**PLANNED UNIT DEVELOPMENT,
PLANNING APPROVAL &
SUBDIVISION STAFF REPORT****Date: July 17, 2014**

<u>NAME</u>	Asian Square 2 Subdivision
<u>SUBDIVISION NAME</u>	Asian Square 2 Subdivision
<u>LOCATION</u>	472 and 476 Azalea Road (West side of Azalea Road, 420' ± North of Gaylark Road North)
<u>CITY COUNCIL DISTRICT</u>	District 5
<u>PRESENT ZONING</u>	B-2, Neighborhood Business District
<u>AREA OF PROPERTY</u>	2 lots / 0.6 ± acres
<u>CONTEMPLATED USE</u>	Planning Approval to allow a seafood store in a B-2, Neighborhood Business District, Planned Unit Development approval to allow shared parking between two building sites, and Subdivision approval to create two legal lots.
<u>TIME SCHEDULE FOR DEVELOPMENT</u>	Not specified.
<u>ENGINEERING COMMENTS</u>

SITE PLAN

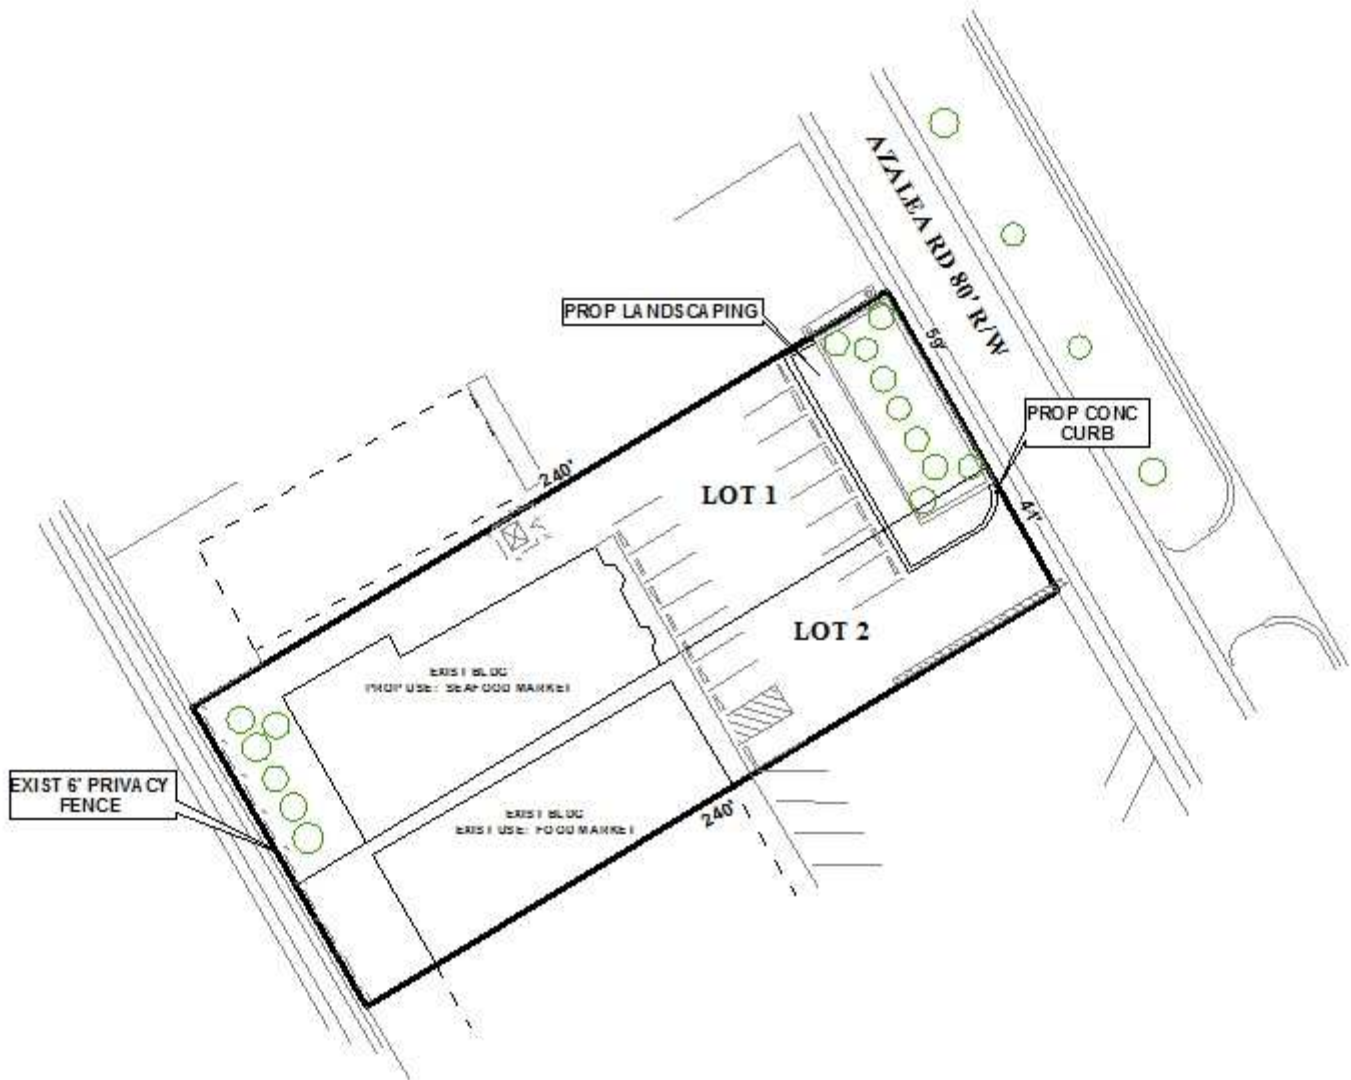
Parking and maneuvering areas appear to be compliant with Section 64-6. of the Zoning Ordinance as it relates to accessibility, bumper stops, stall and aisle dimensions, and quantity (for both retail and warehouse uses). Currently, the site does not have a curb-cut to Azalea Road as access is via adjacent property; however, the applicant is proposing to provide a curb-cut to Azalea Road so that the inclusion of the adjacent property to the south in the PUD is not required. As a means of access management, both proposed lots should be limited to proposed one (1) shared curb-cut, with any changes to the size, design, and location to be approved by Traffic Engineering and conform to AASHTO standards. Also, any future development should be limited to retail, office, and food uses with a parking ratio of 1 parking space per 300 square feet, or new applications will be required.

It should be noted that the site plan does not depict the proposed onsite traffic circulation nor show the location of any proposed freestanding or monument sign structures. Any revised site plan should depict onsite traffic circulation and the location of any proposed sign structures, if applicable.

It should also be pointed out that the site plan does not depict a sidewalk along Azalea Road; however, a note on the site plan states that the applicant is requesting a Sidewalk Waiver. As such, the submission of a Sidewalk Waiver request is required, and if denied, a revised site plan should be submitted depicting a sidewalk along Azalea Road.

Trees and landscaping are illustrated on the site plan; however, it appears the proposed tree credits were calculated using an incorrect calculation, which affects the total number of trees

which may be required on site, should the credits not be sufficient. The site plan should be revised to quantify and illustrate full compliance with the tree and landscaping requirements of Section 64-4.E. of the Zoning Ordinance.

The site plan depicts a proposed dumpster pad with screening along the northern property line of the proposed Lot 1. If approved, a note should be placed on the Final Plat and site plan stating compliance with Section 64-4.D.9. of the Zoning Ordinance regarding dumpster compliance.

The site is adjacent to R-1, Single-family Residential along the site's western lot line. The site plan depicts an existing 6' wooden privacy fence along said lot line, which should satisfy the buffer requirement of the Zoning Ordinance.

- 1) Depiction of a sidewalk along Azalea Road or the submission of a Sidewalk Waiver request;
- 2) Revision of the site plan to illustrate and quantify full compliance with the tree and landscaping requirements of Section 64-4.E. of the Zoning Ordinance;
- 3) Revision of the site plan to depict the 25' minimum building setback line;
- 4) Revision of the site plan to depict the proposed onsite traffic circulation;
- 5) Revision of the site plan to depict the location of any proposed freestanding or monument sign;
- 6) Placement of a note on the site plan stating compliance with Section 64-4.D.9. of the Zoning Ordinance regarding dumpster compliance;
